# UNITED STATES PATENT AND TRADEMARK OFFICE

10/630,460

## Office Action Summary

**DETAILED ACTION**

With regard to claim 1, Estakhri discloses an integrated circuit component (Figs. 1 and 6a, shown below:)

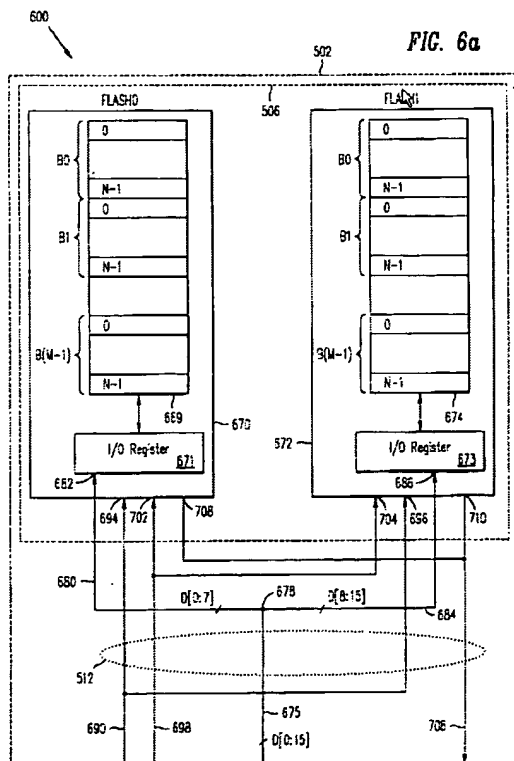
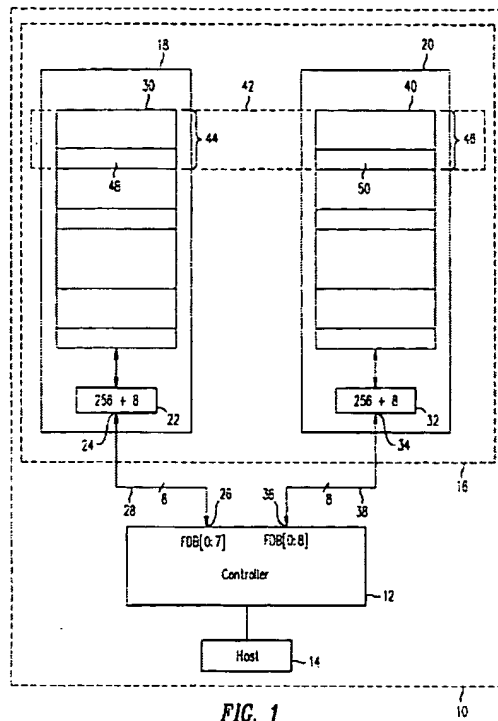
comprising: logic (since 506 is an digital IC and due to the fact that the register must latch to the bus to receive address/data signals, it is clear that the I/O register 22/32 or 671/673 comprises "logic"; see at least column 2, lines 28-37; column 6, lines 57-65) capable of being configured to interface with a first portion of a system bus (28/680; column 1, line 31 to column 2, line 3; column 7, line 1-9); and logic (since 506 is an digital IC and due to the fact that the register must latch to the bus to receive address/data signals, it is clear that the I/O register 22/32 or 671/673 comprises the so-called "logic"; see at least column 2, lines 28-37; column 6, lines 57-65) capable of being configured to interface with a companion integrated circuit (18/670 or 20/672; column 1, line 31 to column 2, line 3; column 6, lines 57-65) and to receive information that is communicated from the companion integrated circuit, which information was communicated to the companion integrated circuit via a second portion of the system bus (38/684; column 1, line 31 to column 3, line 2; column 7, lines 1-9).

Contrary to Applicants' argument, Estakhri discloses an integrated circuit component (Figs. 1 and 6a) comprising: logic (since 506 is an digital IC and due to the fact that the register must latch to the bus to receive address/data signals, it is clear that the I/O register 22/32 or 671/673 comprises "logic"; see at least column 2, lines 28-37; column 6, lines 57-65) capable of being configured to interface with a first portion of a system bus (28/680; column 1, line 31 to column 2, line 3; column 7, line 1-9); and logic (since 506 is an digital IC and due to the fact that the register must latch to the bus to receive address/data signals, it is clear that the I/O register 22/32 or 671/673 comprises the so-called "logic"; see at least column 2, lines 28-37; column 6, lines 57-65) capable

Contrary to Applicants' argument, it is clear from at least Fig. 6a of Estakhri that the first companion integrated circuit (18/670) and the second companion integrated circuit (20/672) each is disposed in a single integrated circuit chip.
